Quality Control Report

Consultant **Wahib Medanat** Consultant Engineers
Site Name **Hay Al Iskan Basic mixed - Jerash**
Package **Package 2**
Contractor **Dijlah Est. Construction Co.**
Tender No. **10/2019/USAID/SKEP/3/2**

Rep No. **QC-21 03**
Date **1 / 03 / 2021**

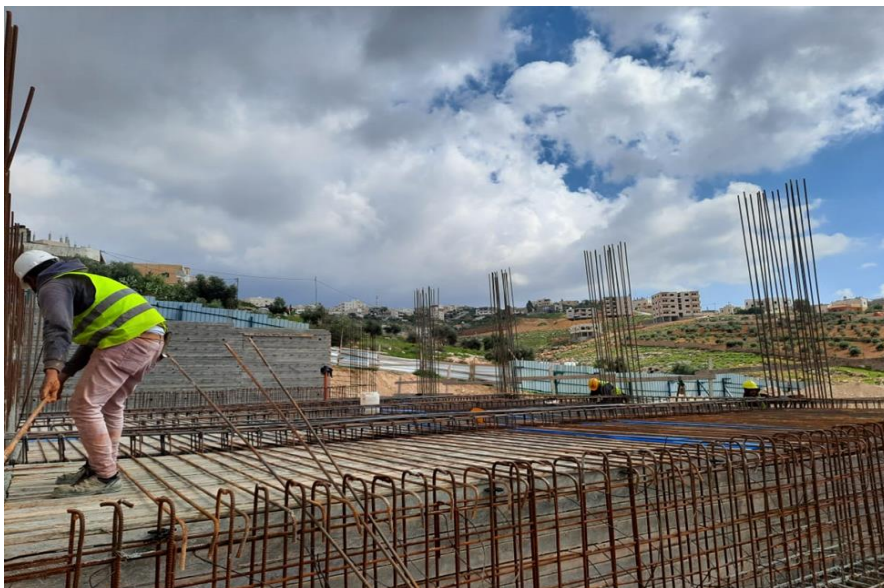
Description of Non Conformance	Corrective Action	Required by / When
<p>1- The wood used for shuttering of the solid slab of basement axis (A-D/ 7-10) is overused and defected. (Attached Photos).</p> <p>2- The Contractor did not submit a job request for the Supervision Engineer to inspect the shuttering before further work.</p>	<p>1- The defected shuttering should be removed and replaced by new wood</p> <p>2- The Contractor is required to follow the contract condition and principles of general practice and request the Supervision Engineer to inspect each stage of work.</p>	<p>Contractor to replace the shuttering as required immediately.</p> <p>Contractor to submit a job request to the Supervision Engineer to each stage of work and for the shuttering of the said slab immediately.</p>

The Contractor is expected to remove the defected shuttering and the said action will be documented as required.
